ARCHITECTURAL REVIEW BOARD MEETING

Thursday, July 25, 2024 at 6:30 PM

STAFF REPORT

Meeting Date:	July 25, 2024
Agenda Title:	COA 24-35 40 S. Sixth Street
Requested Action:	Review request for the construction of an enclosed one-story porch on the rear elevation; alteration of the existing window fenestration of the side elevation as part of an interior kitchen remodel, to include installation of exhaust vents on same elevation.
Department / Agency Lead:	Community Development
Staff Lead:	Casey Squyres, Historic Preservation Planner

1 PROPOSED PORCH PLAN
A1 Scale: 1/4" = 1'-0"

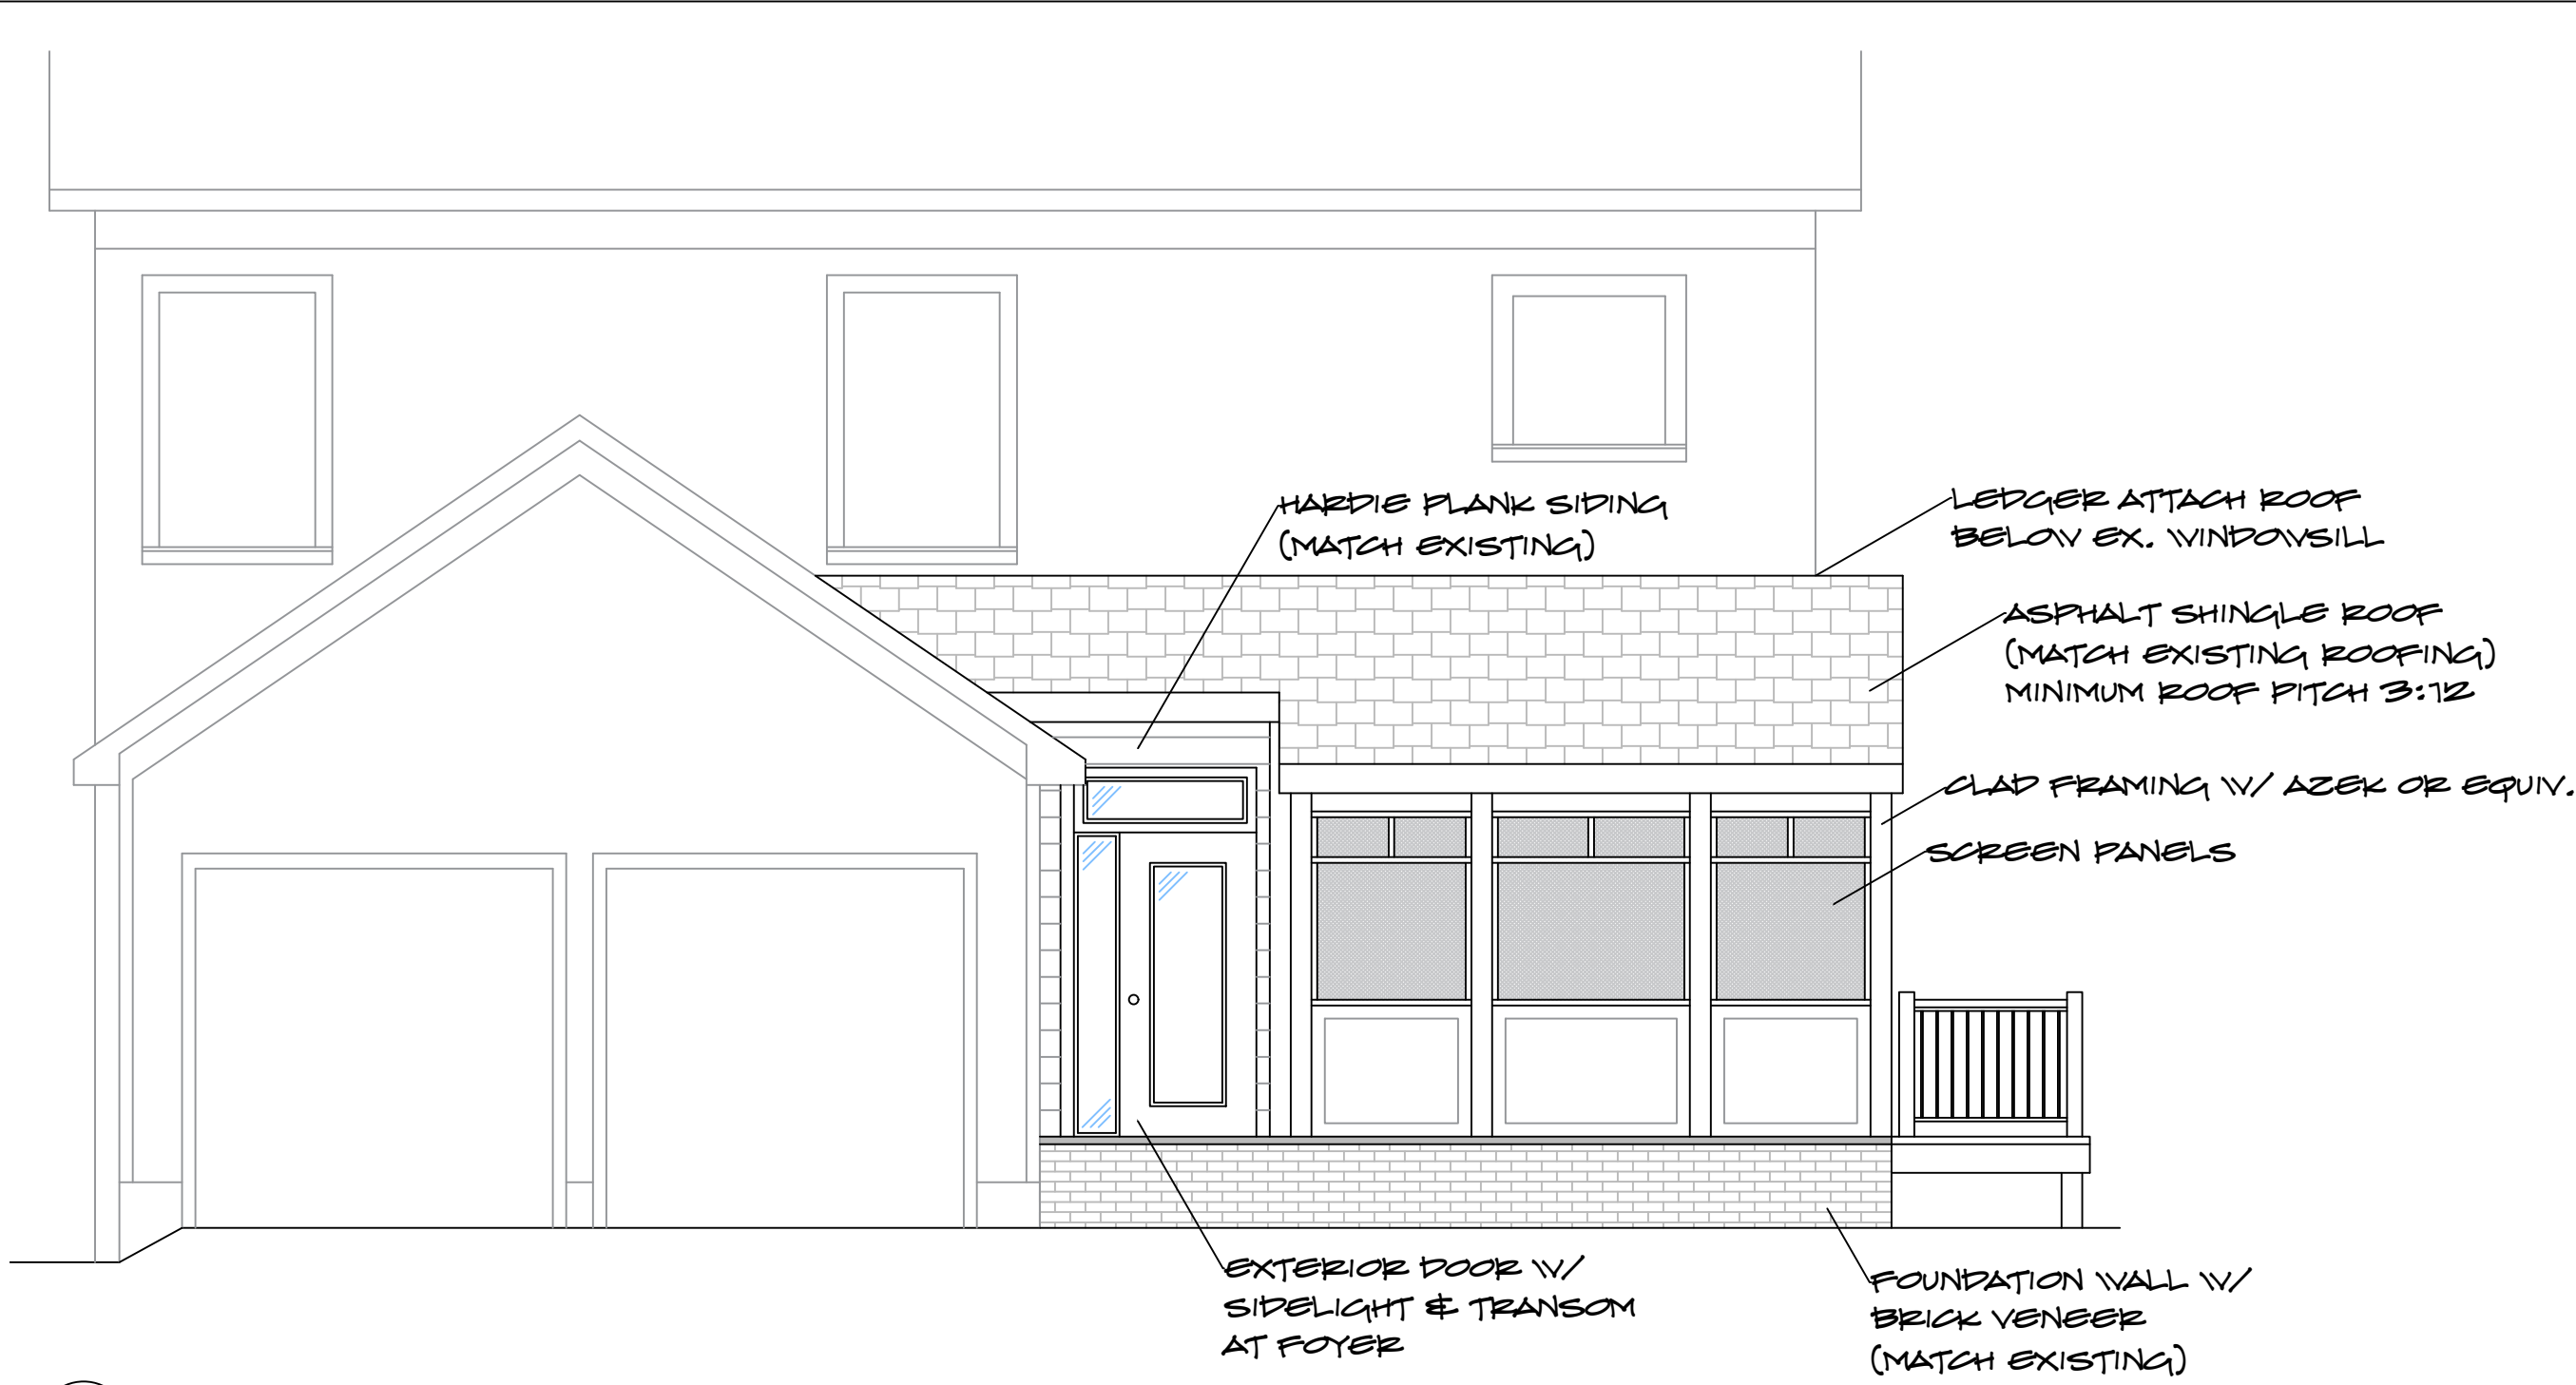
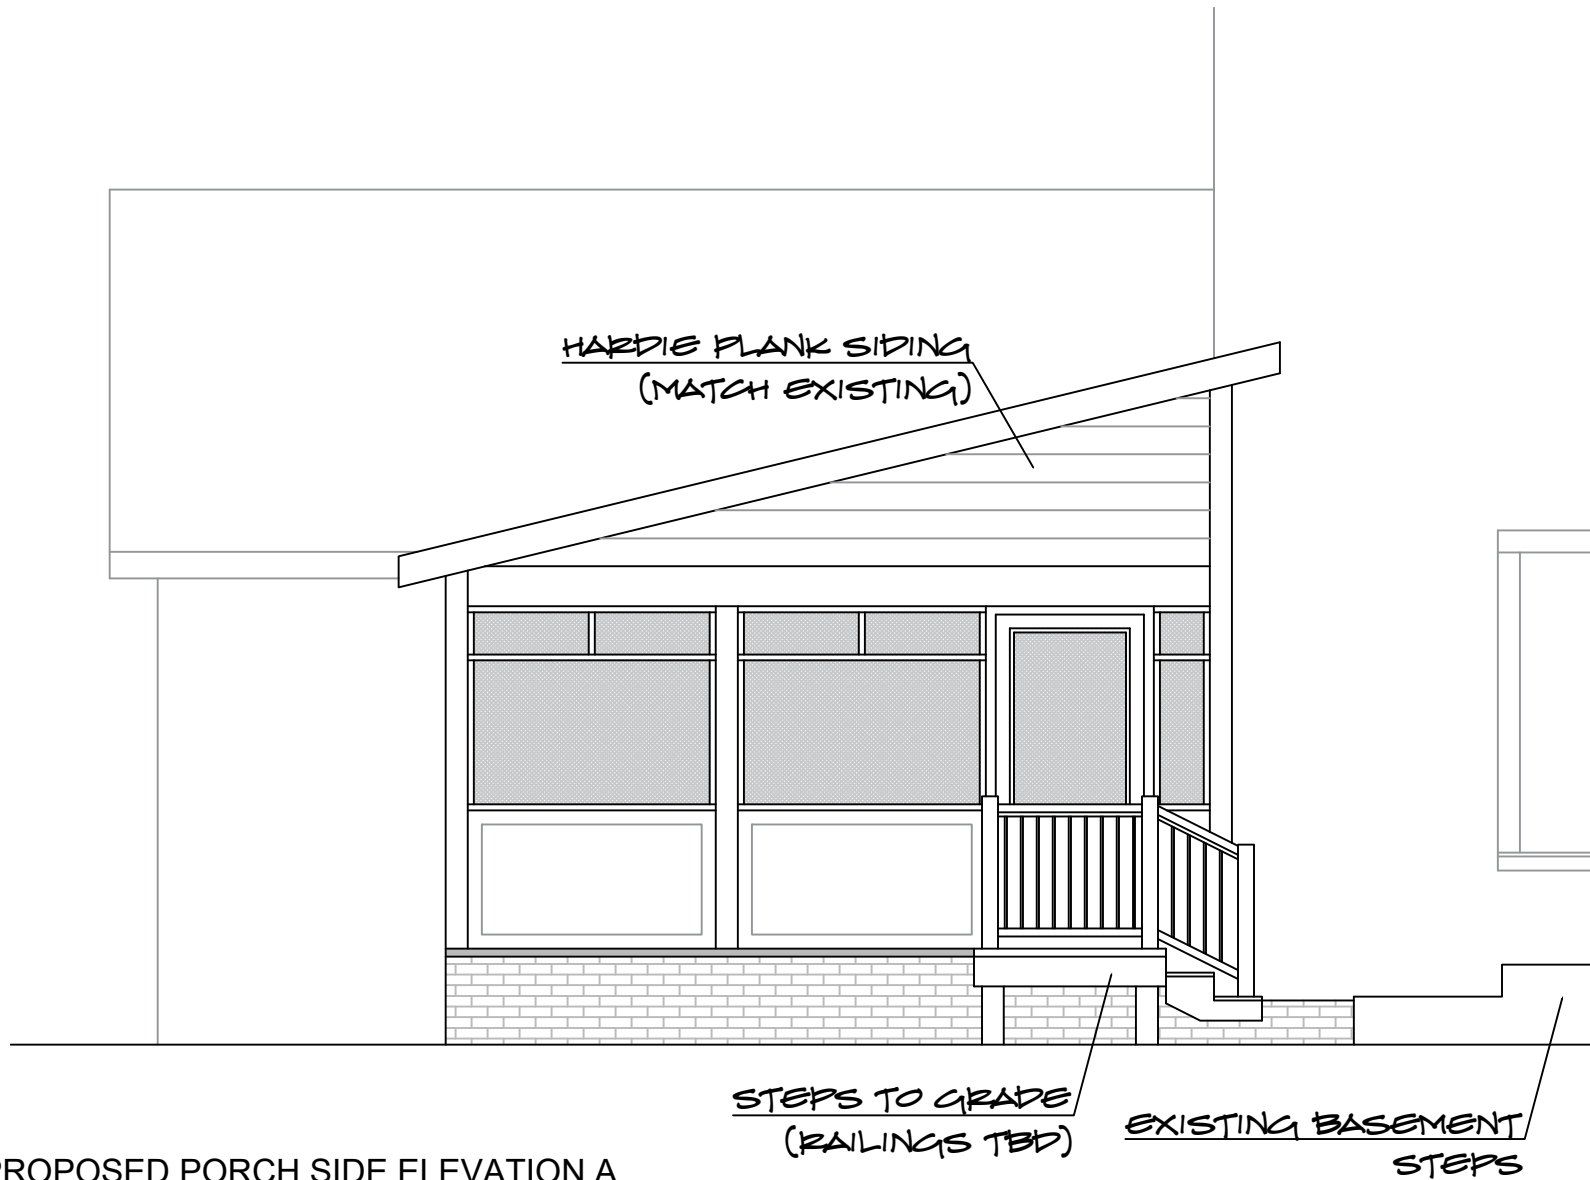
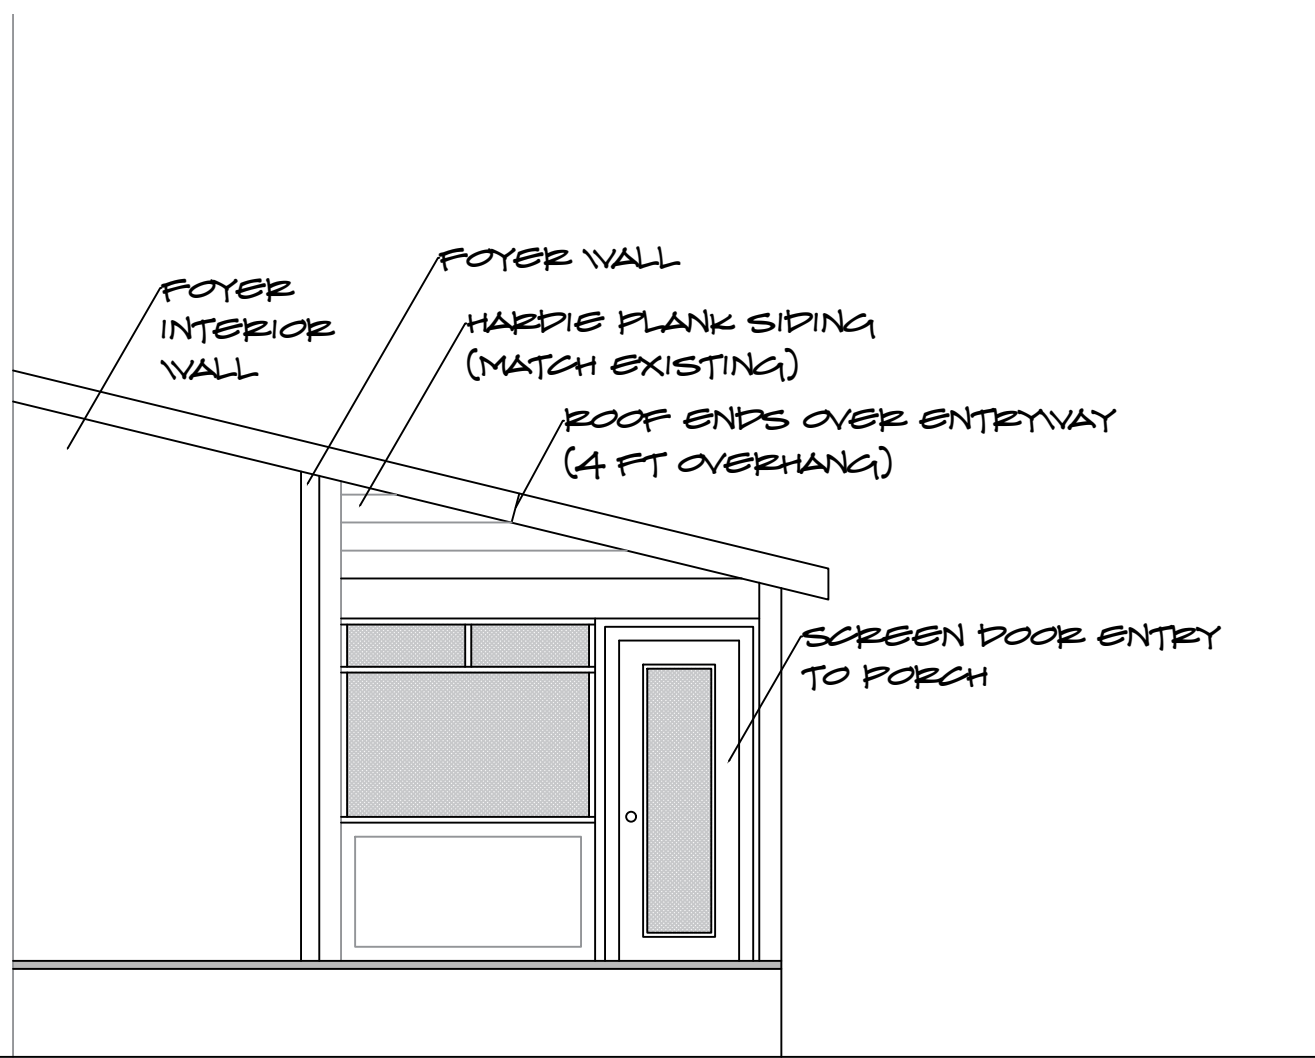
- 3) Proposed porch at 40 S. Sixth Street will be 14' x 14', one-story, shed roof clad in asphalt shingles to match the existing main roof. Siding for the porch will be clad in Hardie Plank siding to match the existing house.

- 4) A small stoop with two steps and iron railing (to match existing iron railing leading to basement) will be installed at the door to the enclosed porch.

- 1) All necessary permits are acquired.
- 2) The ARB suggests that the Applicant consider brick masonry for the new stoop off of the porch to match the existing masonry leading to the basement.
